Addendum # 1

**Bid Opportunity: RFP-549-2024 - General
Contractor Renovation MPAC Pickering, 10th
Floor**

End of Addendum Number: AD-01

REFLECTED CEILING PLAN

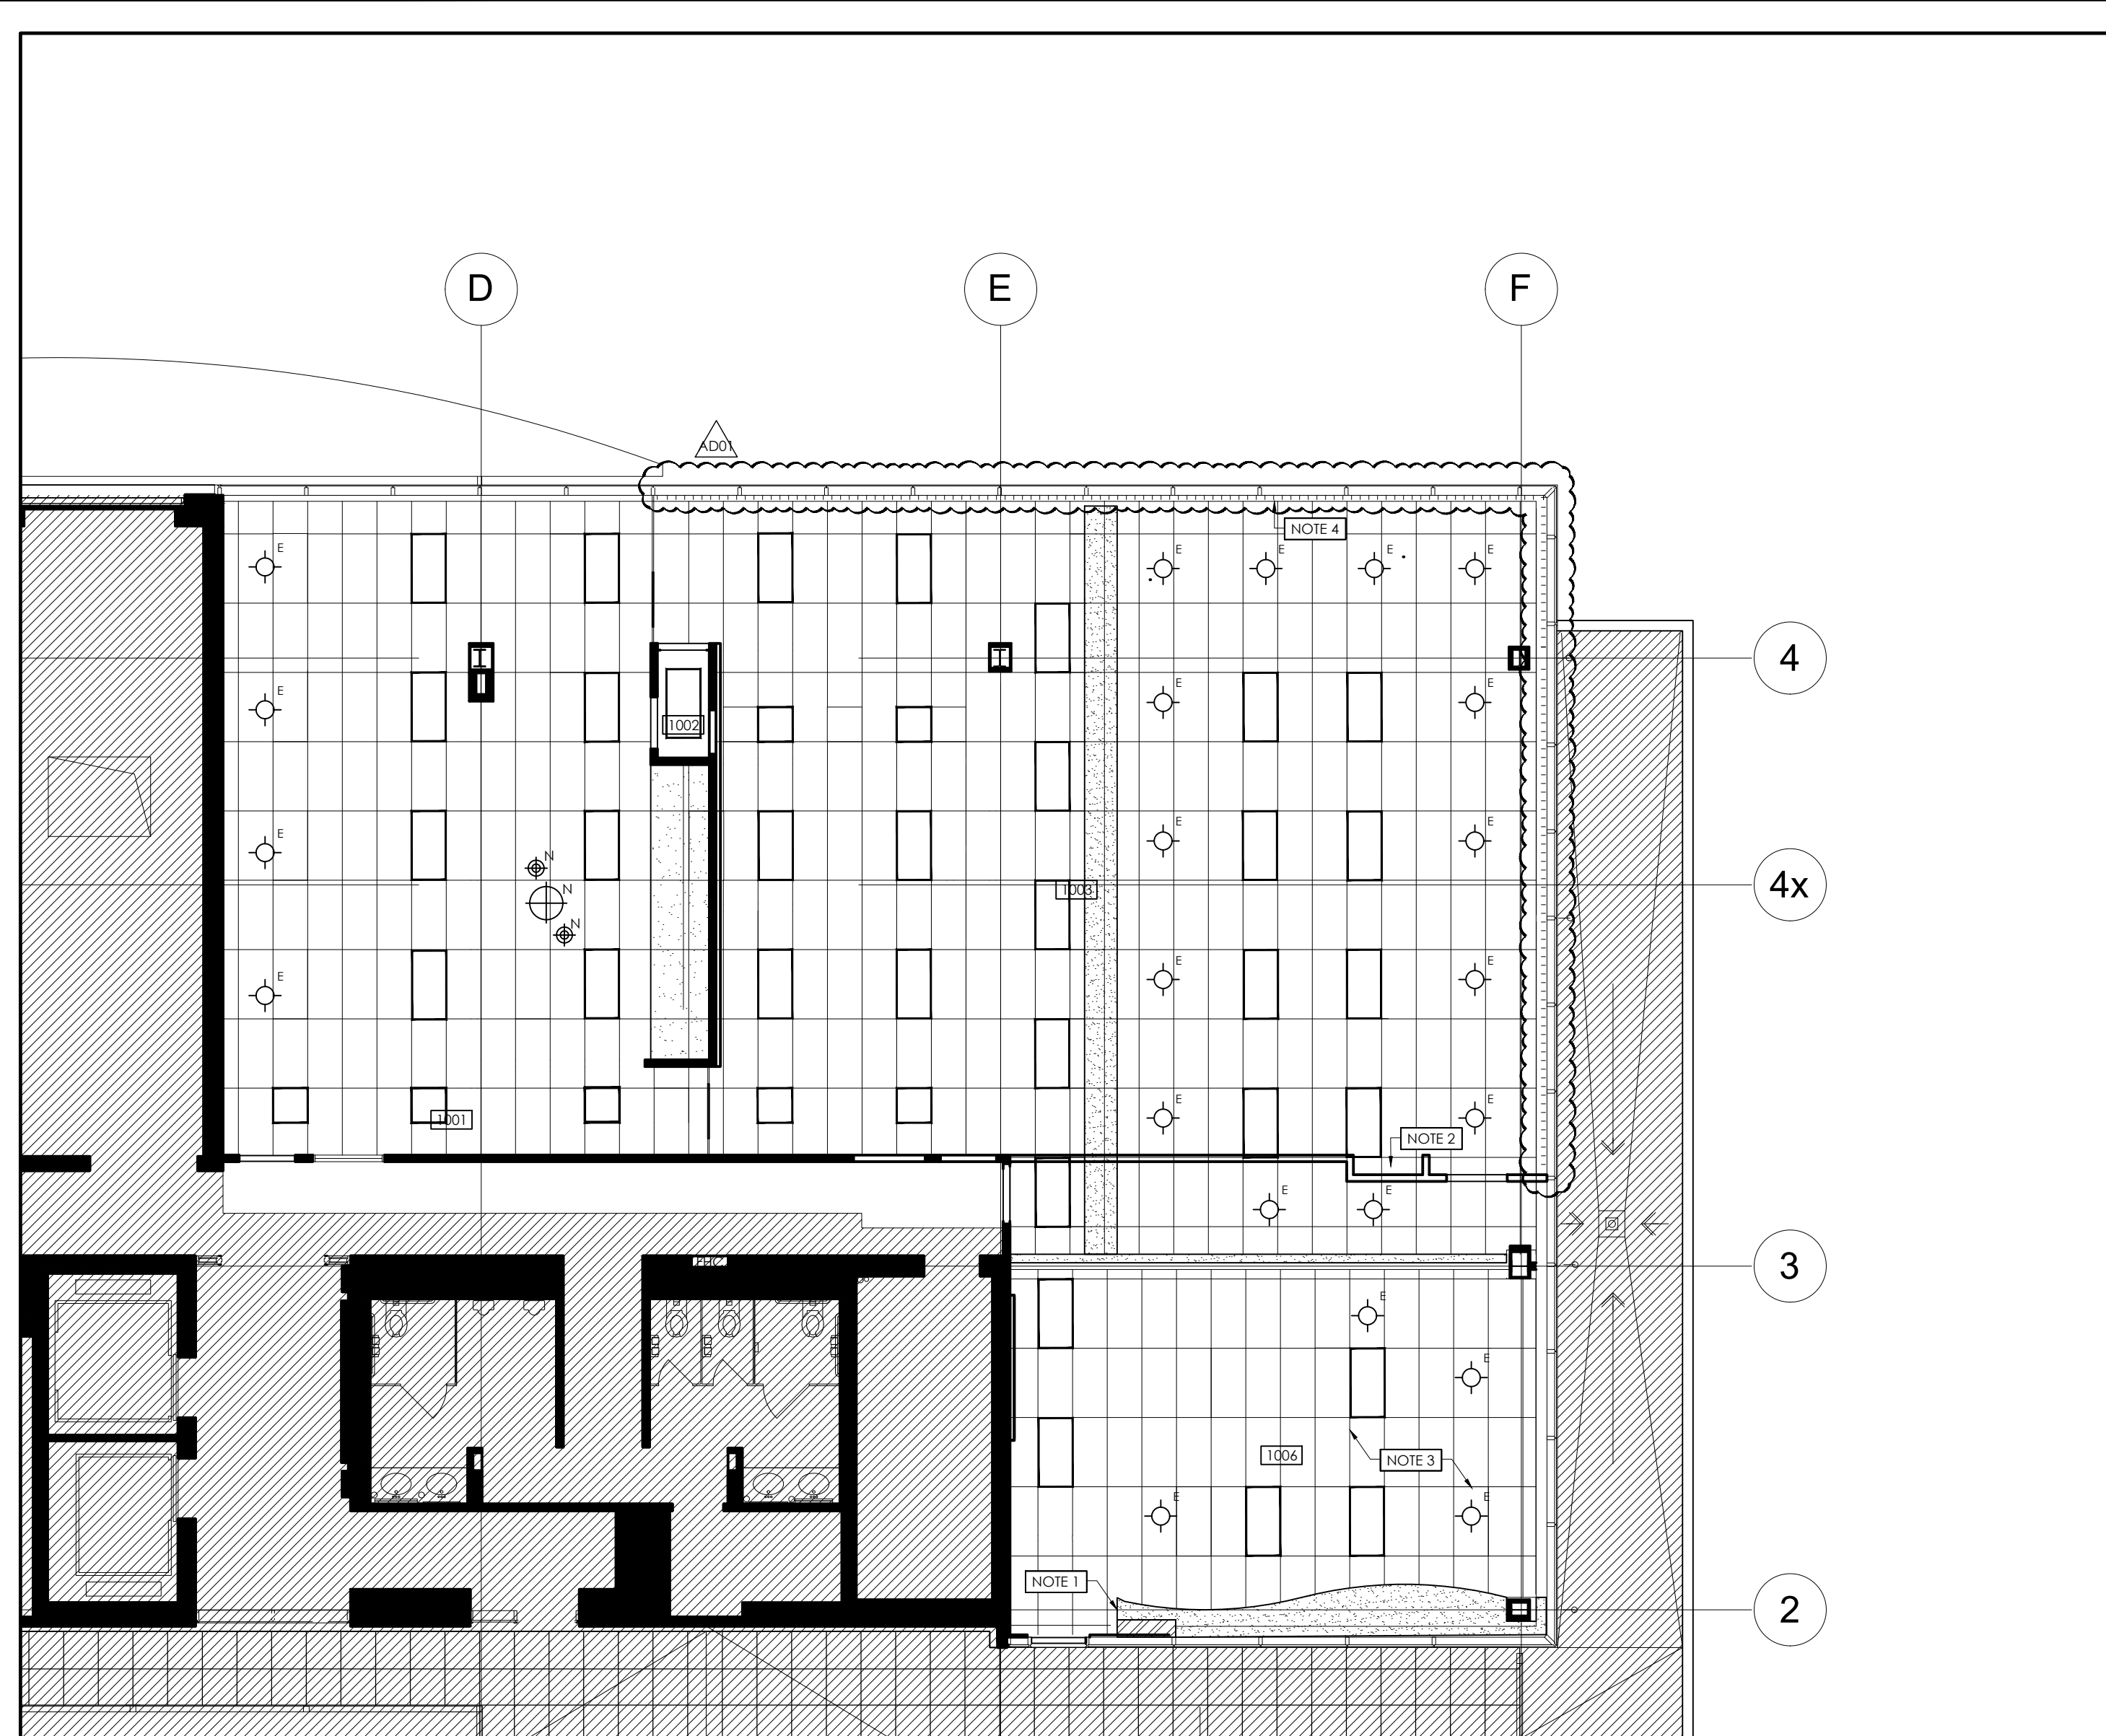
3.0	d. Can you confirm if you are requiring draperies or blinds? e. Notes ask for a stacking diagram for break up of panels.
	Answer: Dual Roller shades are required. (Blackout & Glare Reduction) To be mounted at glazing frames similar to existing. Stacking diagram note is obsolete and has been removed. Refer mark up on I-1002 issued with this Addendum.

10.0	Referencing I-1002: Please confirm if there is new bulkhead required in cafe as shown on the plan.
	Answer: No Bulkhead – existing ceiling to remain.

11.0	Referencing I-1002: Please provide the specification for the ACT tiles and also confirm percentage of ACT tiles that has to be replaced.
	Answer: Specification to be confirmed on site. Percentage of damaged tiles for replacement to be determined by contractor on completion of demolition.

1 WALL FINISHES PLAN
 1/8" = 1'-0"

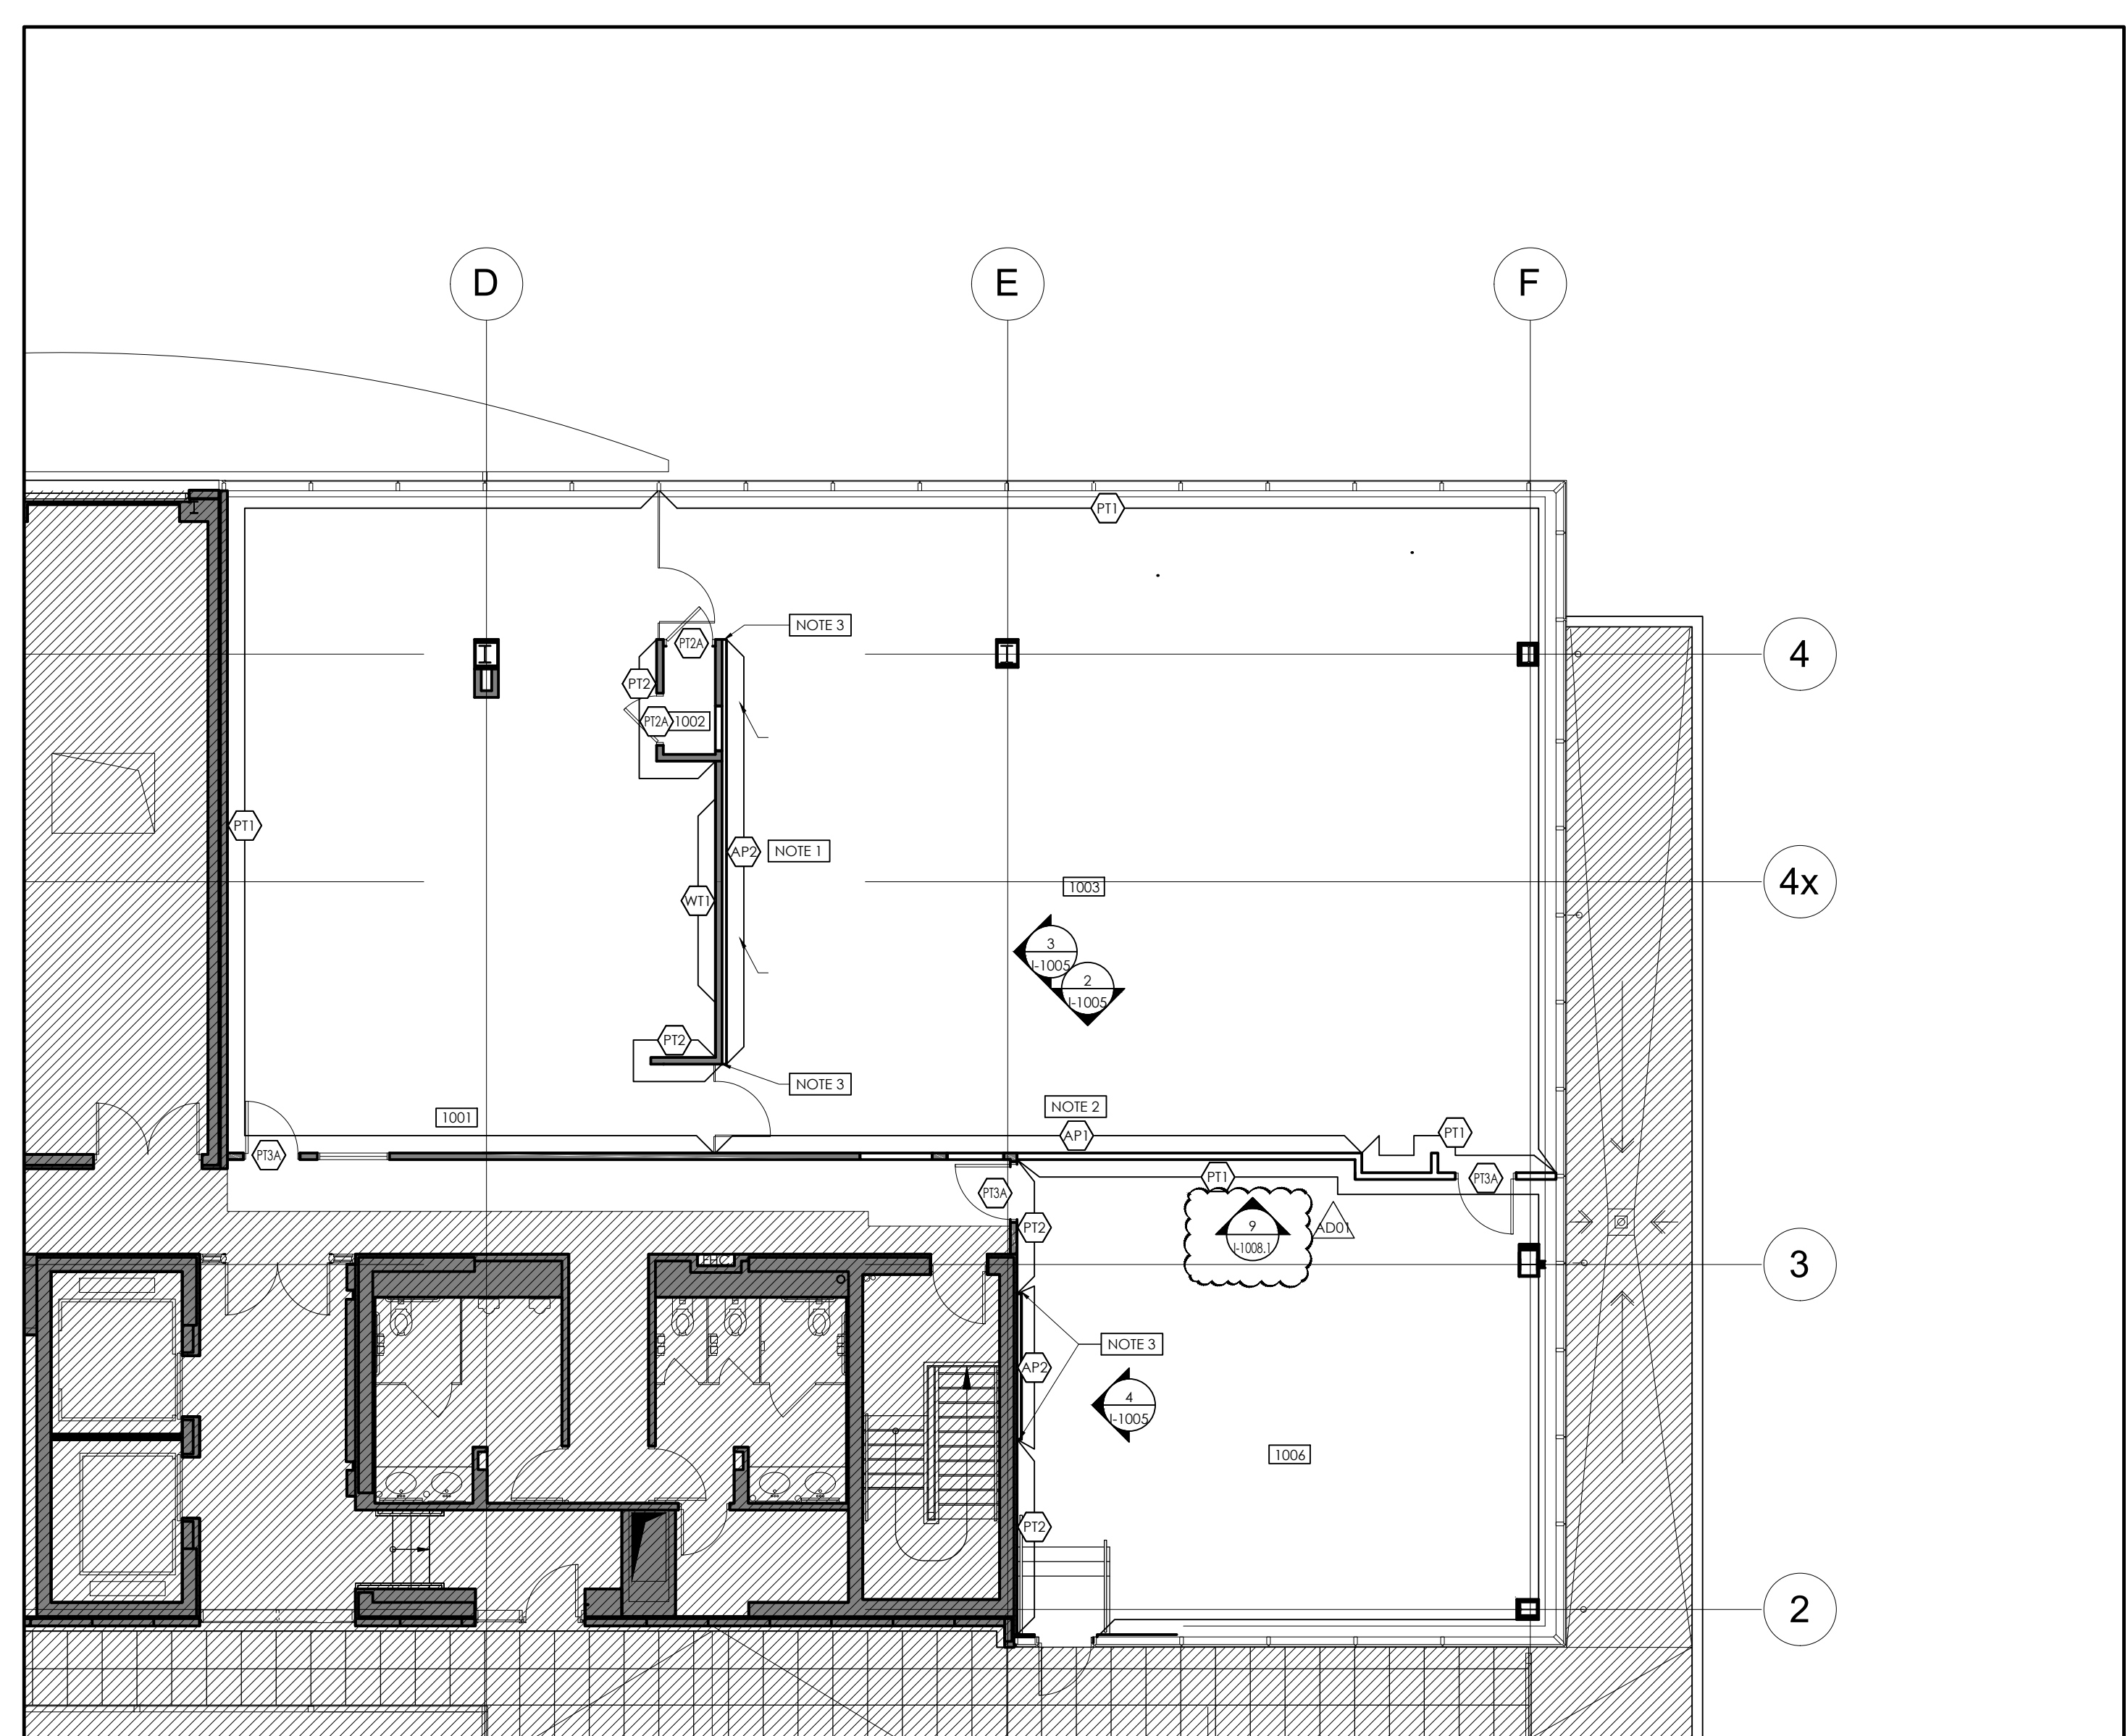
14.0	Referencing I-1008.1 Detail 3: Please advise what is this elevation and provide more details and information.
	Answer: This elevation is a living wall to be procured by the owner. The elevation is for coordination purposes only. Detail has been updated to number 9, and elevation tag added to wall finishes plan. Reference 1/ I-1005.

7 PLAN: AREA
1/4" = 1'-0"

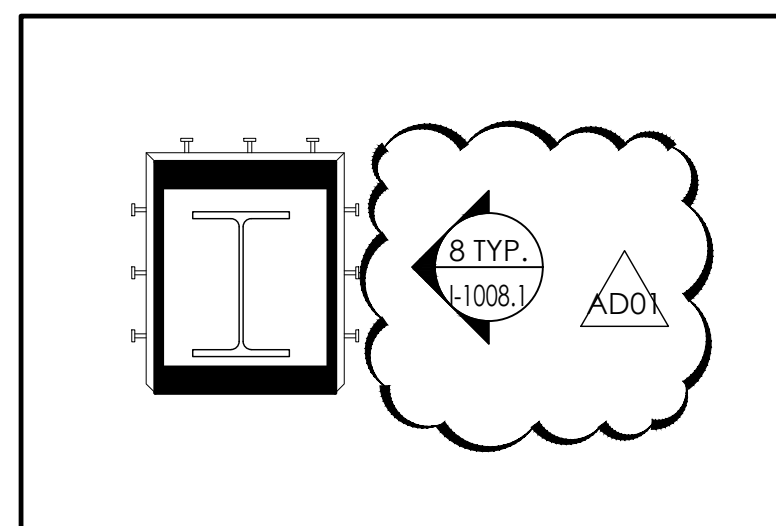
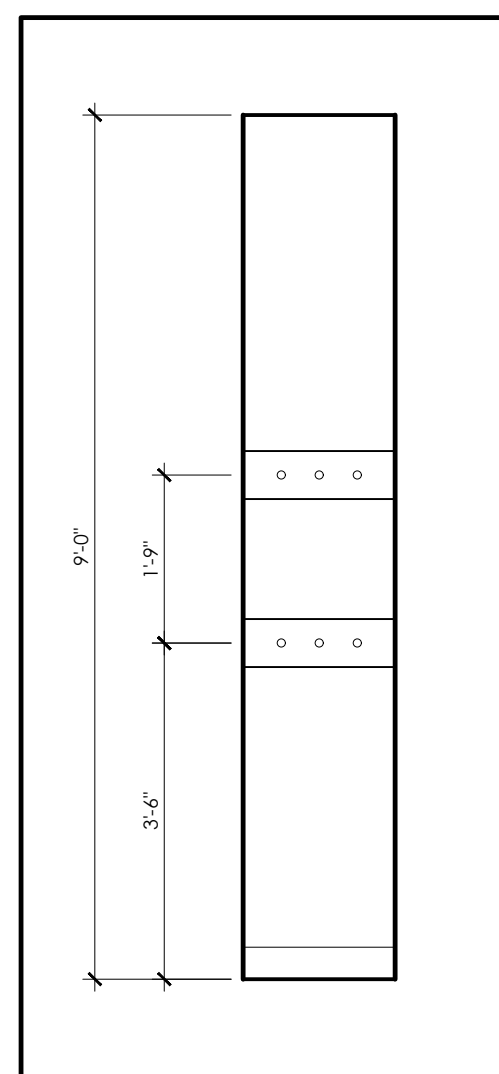
13.0	Referencing I-1008.1 Detail 2: Please confirm how many of the columns we have to clad?
	Answer: No cladding required, mark up of location of coat hooks provided with this Addendum, Refer I-1001, Note 5.
